Written Representation on Behalf of the Neighbours and Users of Queen Elizabeth Park

Interested Party reference no: **20022545**

1. Summary

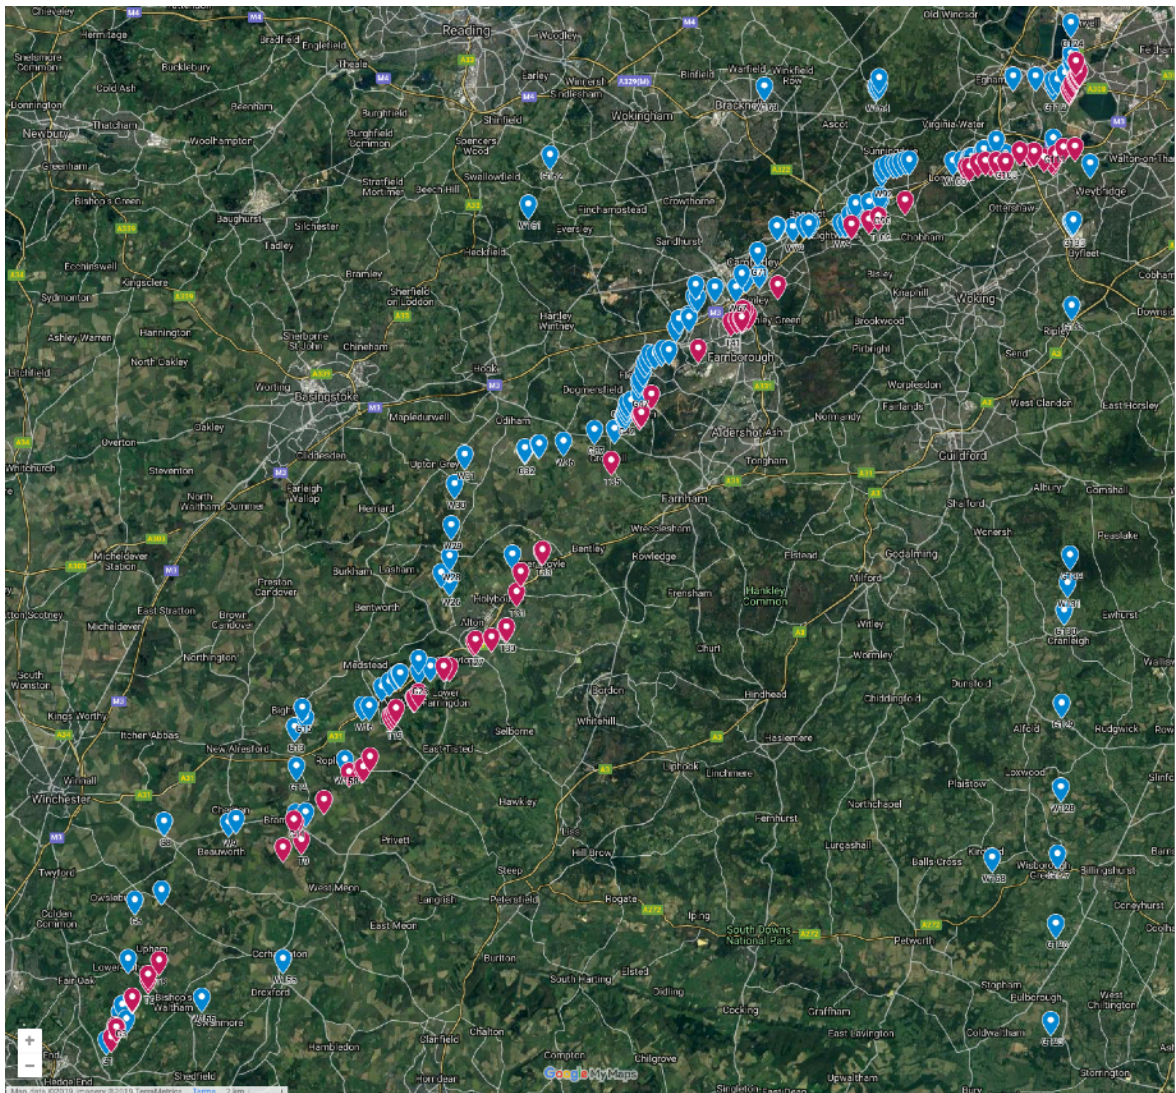
The image below illustrates the errors in the positions of tree groups in Esso's Schedule of Notable Trees³⁹.

Red markers show individual trees listed in Table 1.2 of the schedule and we believe that these are accurate. The trail of red markers roughly follows the proposed route of the pipeline.

Blue markers show the tree groups listed in Table 1.3 of the schedule, most of which are inaccurate. Many are offset to the north whilst some inexplicably form a north-south line through Surrey and Sussex.

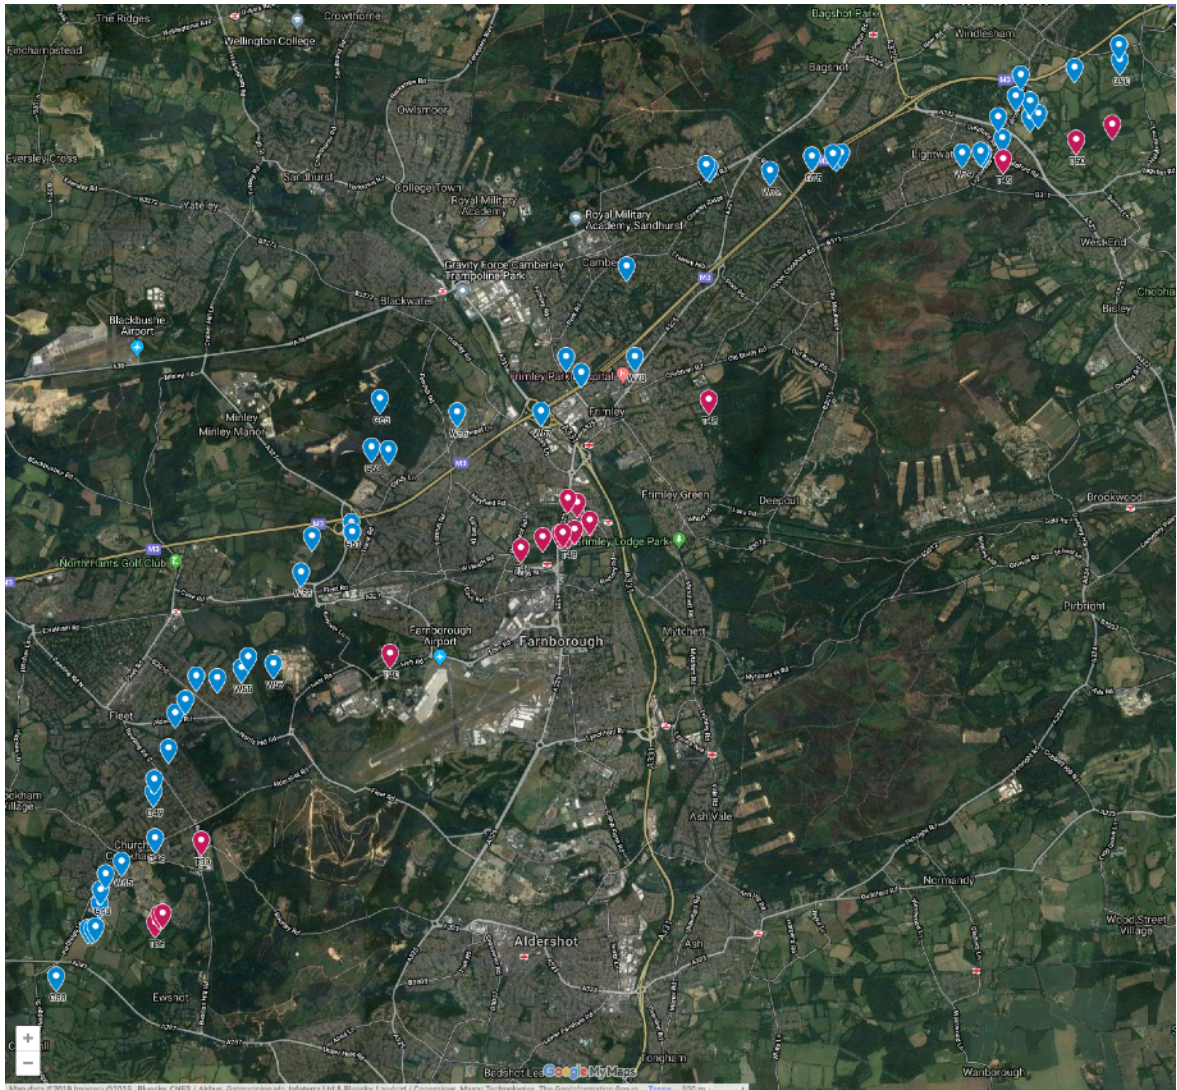
This enlargement shows the Farnborough area and illustrates more clearly how far away from the proposed route the co-ordinates of the tree groups are. The red markers are roughly aligned with the proposed route of the pipeline.
